UNITED STATES  
NUCLEAR REGULATORY COMMISSION  
REGION I  
631 PARK AVENUE  
KING OF PRUSSIA, PENNSYLVANIA 19406

IE Bulletin No. 80-20  
Page 1 of 2

FAILURES OF WESTINGHOUSE TYPE W-2 SPRING RETURN TO NEUTRAL CONTROL SWITCHES

FIGURE 1

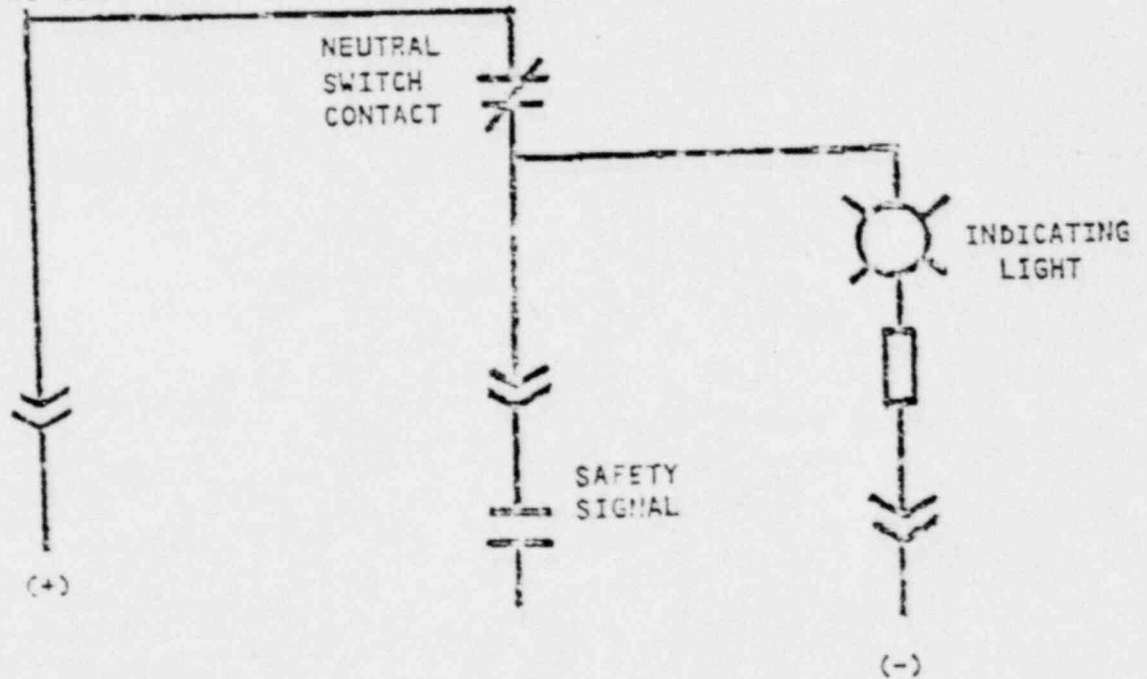
A review of this matter by Westinghouse led to the issuance of NSD Technical Bulletin No. NSD-TB-80-9 to the utility owners of all Westinghouse operating plants. The recommendations contained in the Westinghouse technical bulletin include: (i) testing the neutral position contacts of the subject W-2 switches for continuity, and (ii) rewiring of the indicating light circuit to permit the early detection of a neutral contact failure as shown in Figure 1.

Depending on how the indicating light circuit is wired, loss of continuity thru the neutral position contact of a W-2 switch could remain undetected until the equipment associated with the switch were called upon to operate. Since such a failure would be equivalent to by-passing the system associated with the switch, consideration should be given to rewiring the switches used in safety-related applications as shown in Figure 1. Such rewiring would provide an acceptable means for detecting contact failure, provided the indicating light is in the control room and readily visible by the operator. If the indicating light is not so located, consideration should be given to annunciating the neutral position contact failures at the control room to alert the operator of the inoperable status of a safety-related system. In addition, consideration should be given to adding redundant contacts to the W-2 switches or to replacing the W-2 switches with others having a more positive contact wiping action.

3. Licensees of operating plants and holders of construction permits shall describe the longer term corrective measures planned and the date by which such measures will be implemented by actual installation or by design change, as appropriate. As a minimum, the longer term corrective measures should include rewiring the indicating light as shown in Figure 1 provided the light is readily visible to the control room operator. If not, failures of the neutral position contacts should be annunciated in the control room.

EXISTING INDICATING LIGHT CIRCUIT (TYPICAL)

PROPOSED REWIRING OF INDICATING LIGHT CIRCUIT (TYPICAL)

REWIRING OF INDICATING LIGHT CIRCUIT OF W-2 SWITCHES  
AS RECOMMENDED BY WESTINGHOUSE TECHNICAL BULLETIN NSD-TB-80-9
